STAFF REPORT
1,200 SF STORAGE BUILDING ADDITION
COTTAGE GROVE COMMUNITY HOSPITAL
MTA 2-22
APRIL 20, 2022

Subject: ENGINEERING COMMENTS FOR MTA 2-22 (1515 Village Drive - Cottage Grove Community Hospital 1,200 sf storage)

Date: April 8, 2022

SITE PLAN

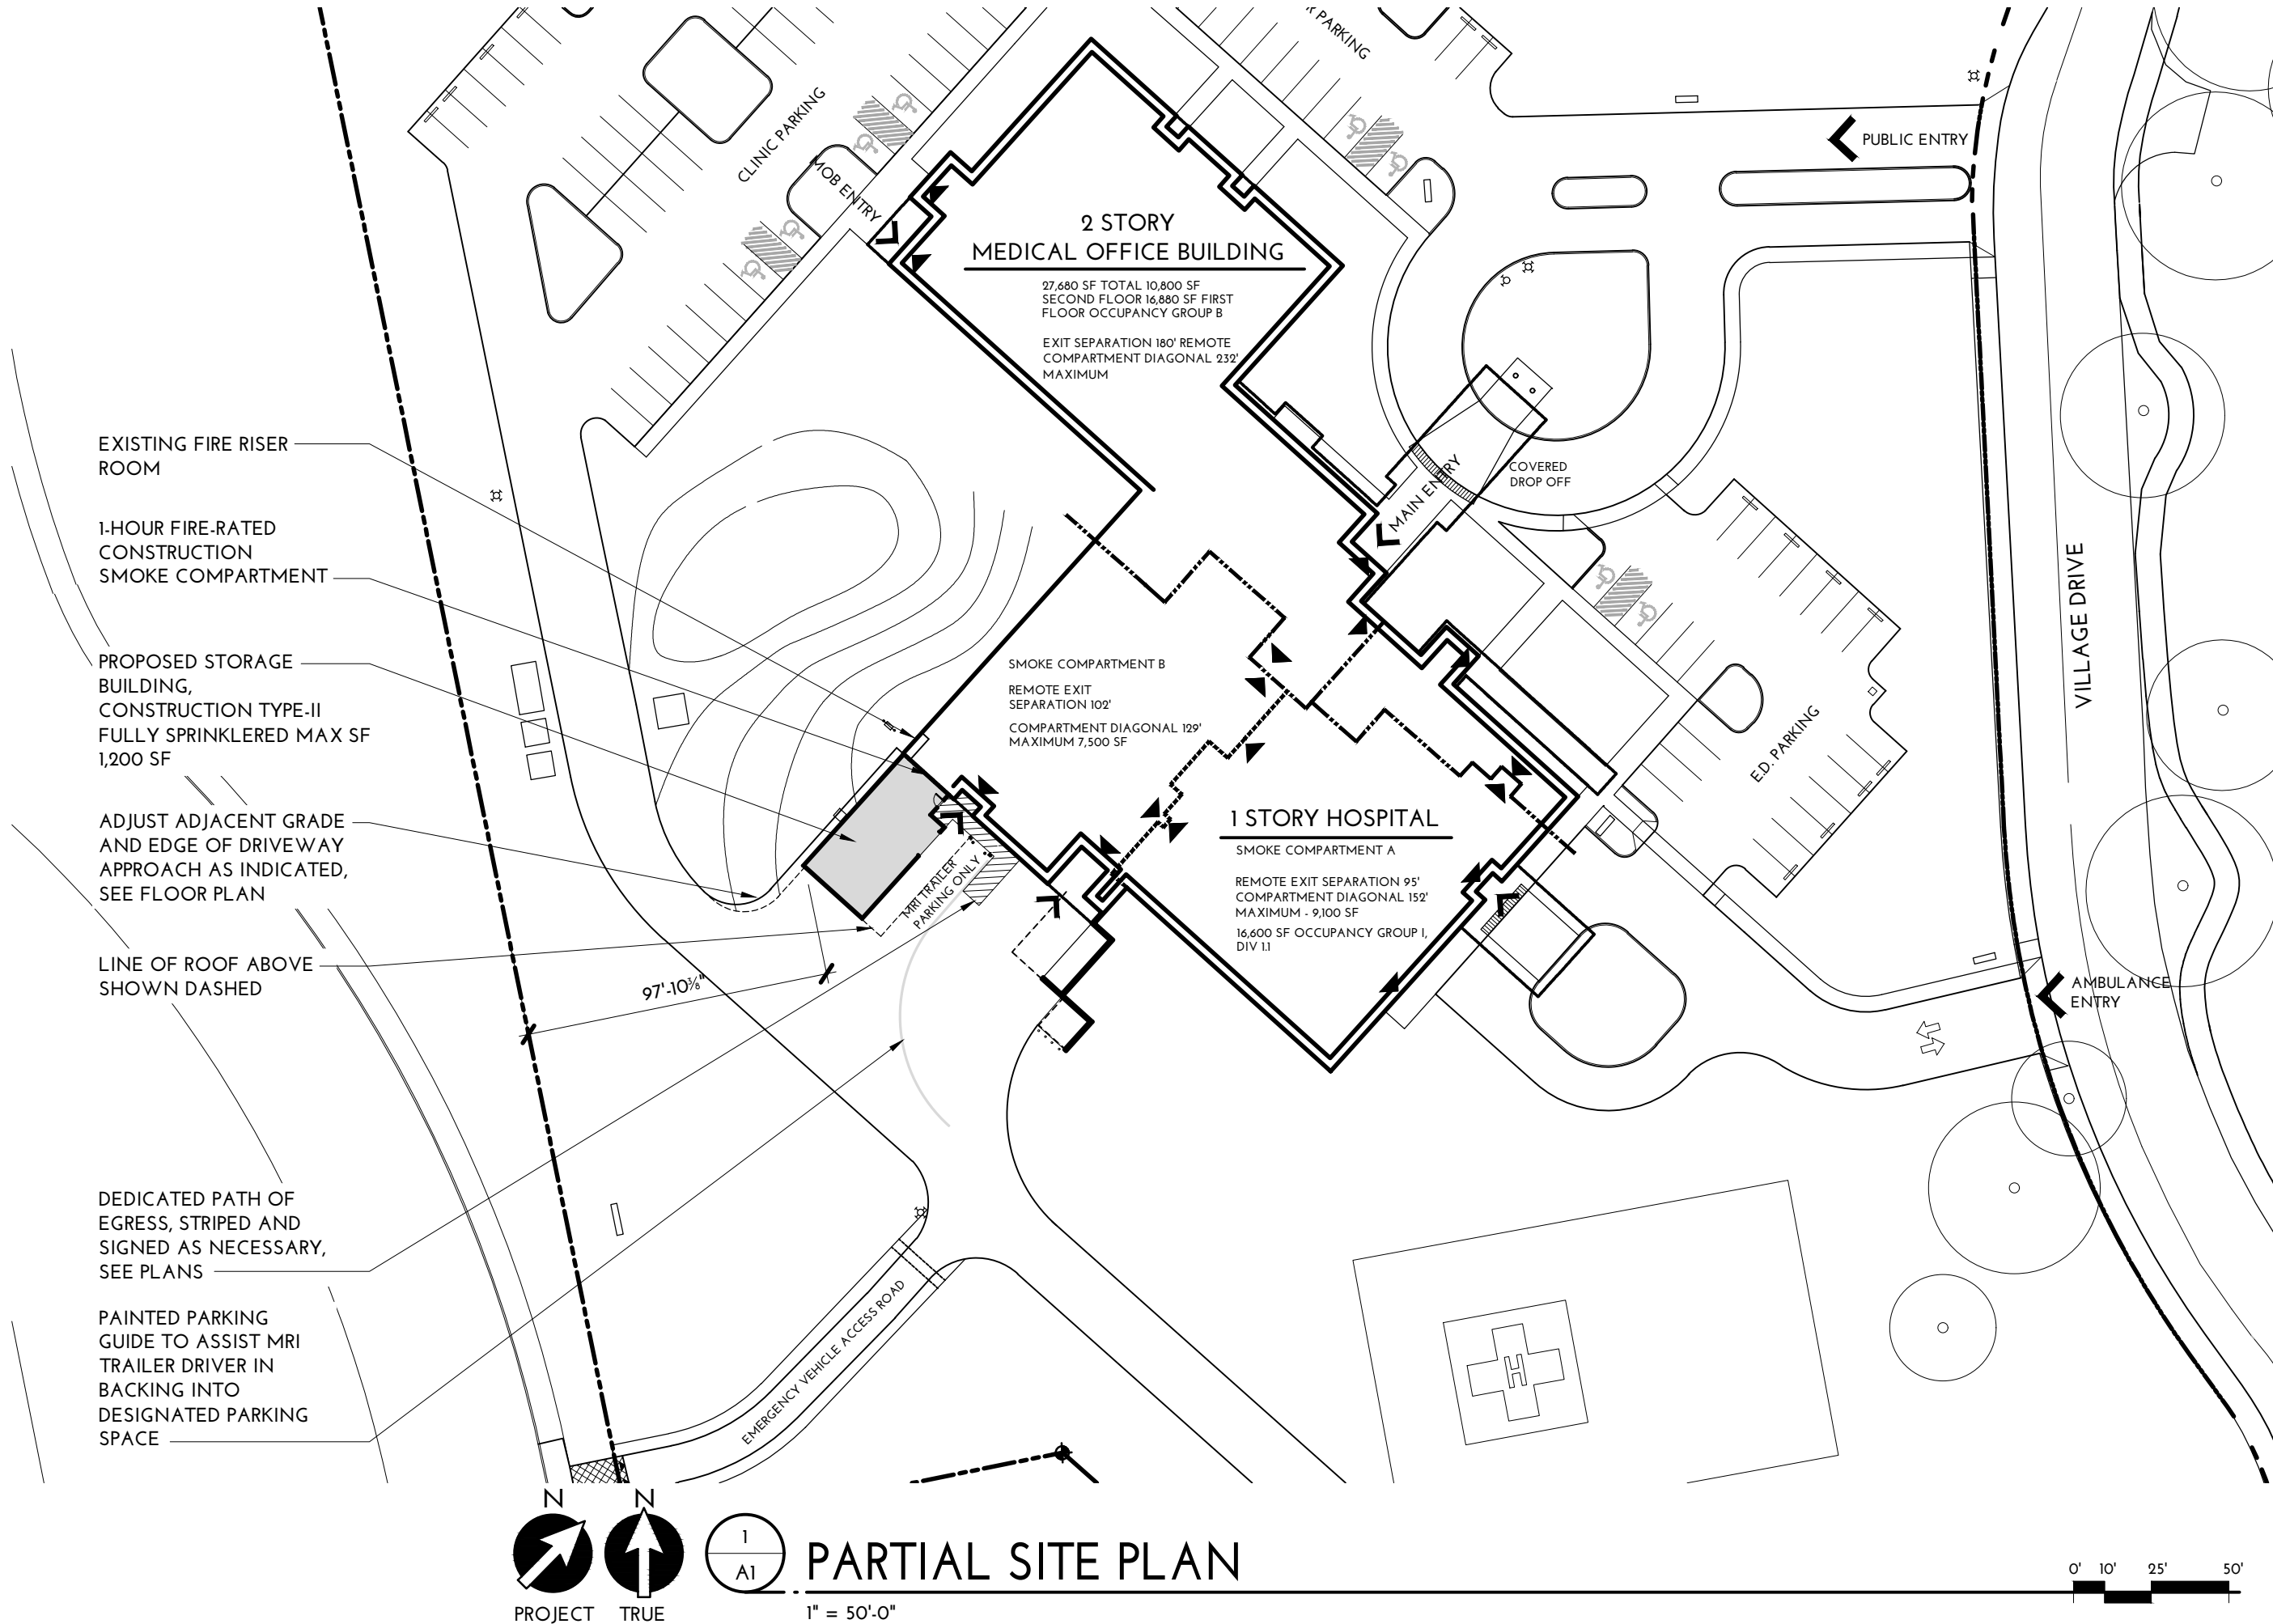
The applicant has provided a site plan (Exhibit C) that demonstrates compliance with all of the standards listed above from Table 14.23.120, as described below.

Lot Coverage: Lot coverage maximum is 60%. The existing buildings and the proposed addition will encumber ~41,000 sf of the total 295,000 sf lot or approximately 14% sqft. As the buildings cover less than 60% of the total lot, this standard is met.

Minimum Setbacks: Minimum setbacks in the CT/L district are met as proposed with the addition being in the rear of the development site and the distance between the west façade of the addition and the nearest property line to the west being approximately 90' away. This criterion is met.

Build-to Line: The proposed addition to the existing structure is approximately 400' from the build-to line, however as this is an addition to the back of the main building the build-to standards do not apply.

1
A6
SOUTH ELEVATION
1/8" = 1'-0"

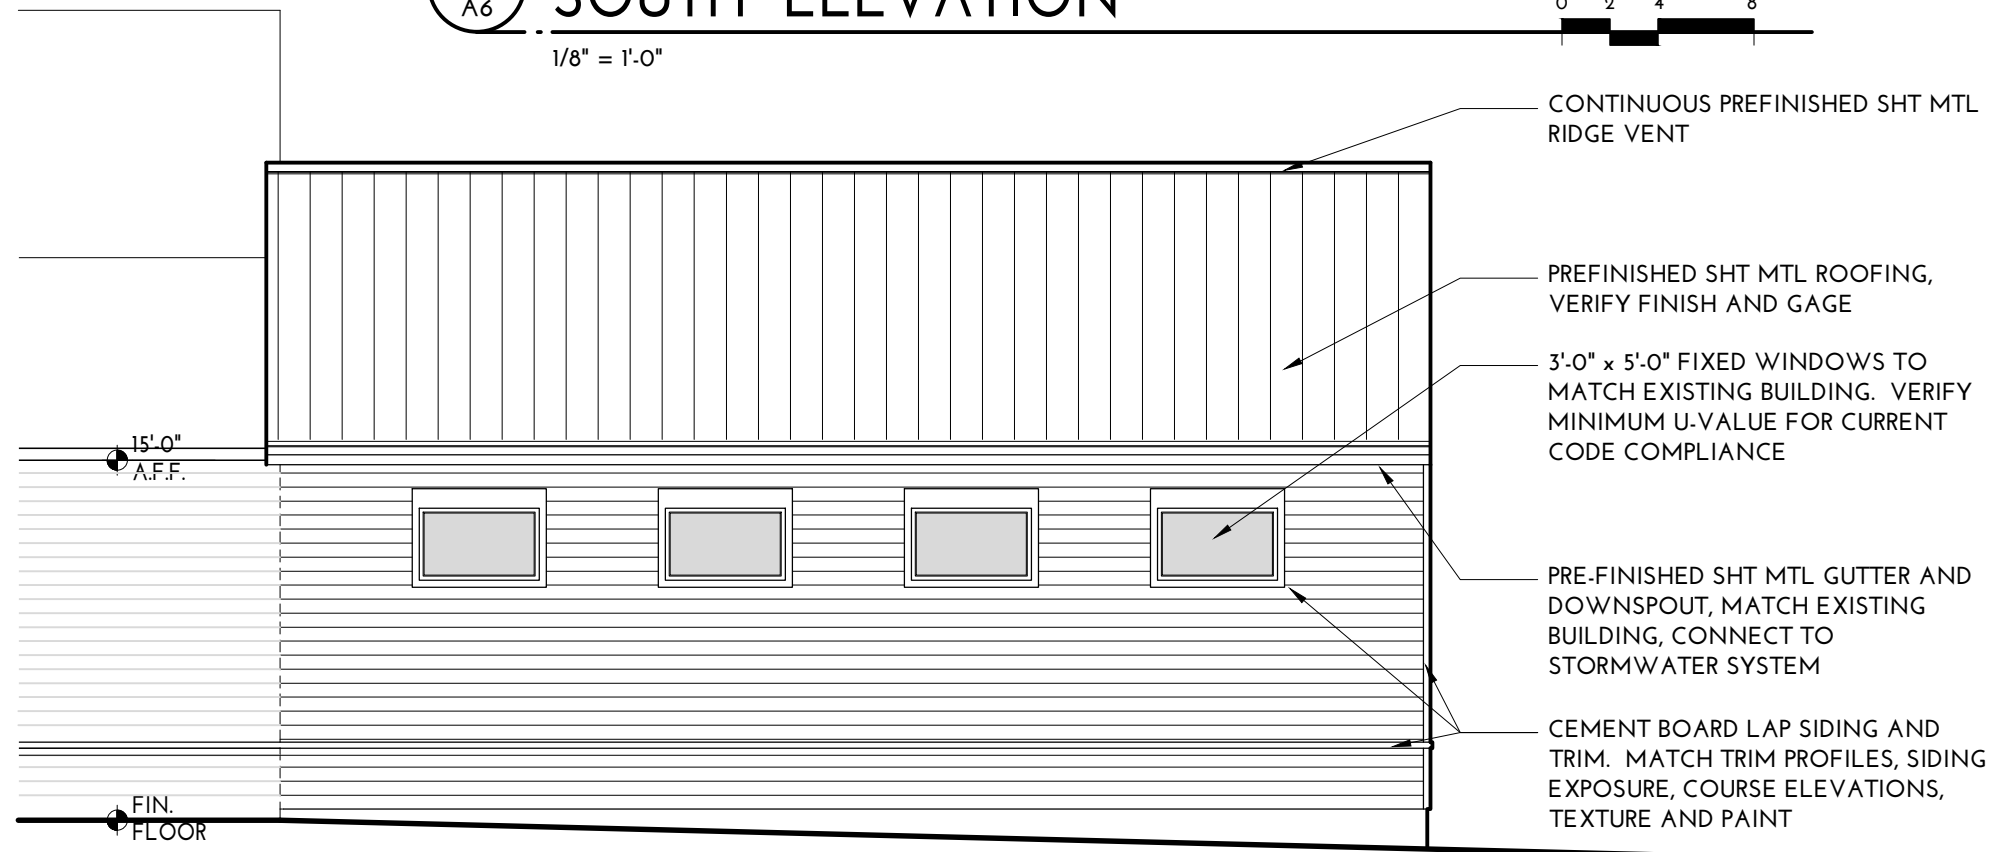
Staff response and findings of fact: The single ridge design of the proposed storage building matches the existing single ridge of the hospital building and with the construction of the addition will provide a stacked gable appearance. This criterion is met.

Staff response and findings of fact: The proposed storage building addition is in the rear of the property, but does demonstrate a window pattern that is in continuity with the existing development. This criterion is met.
